DATE: 12.05.2017
TO: ProTrak
FROM: Mitesh Baxi
 Traffic Engineering

■ **DOLLAR GENERAL-WILMINGTON-CAROLINA BEACH [TRC Plan Review]**

↻ Initial Review Note ↻

BASE INFORMATION:

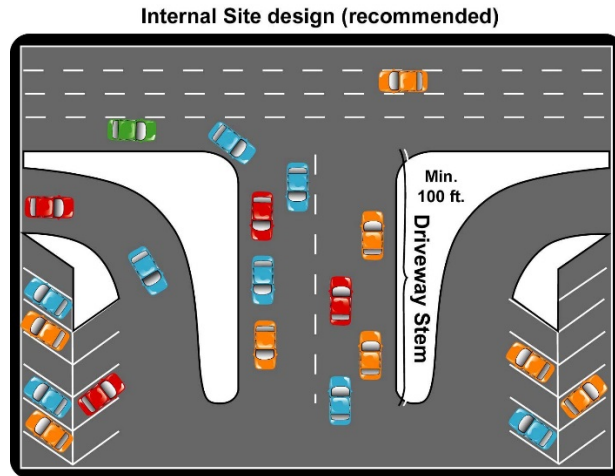
- Revise all sheets to accurately illustrate the existing conditions on and surrounding this parcel. Show all adjacent traffic signs, lane configurations, traffic control devices and pavement markings on the site inventory plan. Please refer to the Technical Standards and Specifications Manual (link is below) Ch. VII C.1.a.2. for specific information and distance requirements. Contact Traffic Engineering at 341-7888 if you need assistance locating these elements.

TECHNICAL STANDARDS – ACCESS (driveway, sidewalk, and sight distance):

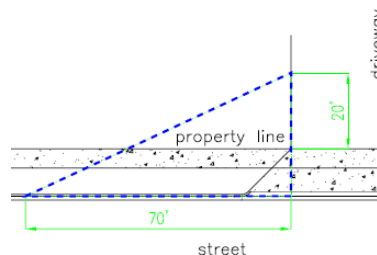
2. Show driveways for adjacent lots and lots across the street.
3. Driveways shall be City-standard ramp-type driveways. Show appropriate City standard detail(s) on plan. [[Chapter VII ,Detail SD 3-03.3 & SD 3-03.4 \(curb\) CofWTSSM](#)]
4. Dimension driveway widths and tapers. [[Sec.18-529 CofW LDC](#)]
5. Provide the curb section details as per [SD 3-11 CofW Tech Stds.](#)
6. Show and apply the City's 20'x70' sight distance triangle at the driveway on the site plan [[Sec.18-529\(c\)\(3\)CofW LDC](#)] Add a note indicating that all proposed vegetation within sight triangles shall not interfere with clear visual sight lines from 30"-10'. [[Sec.18-556 CofW LDC](#)]
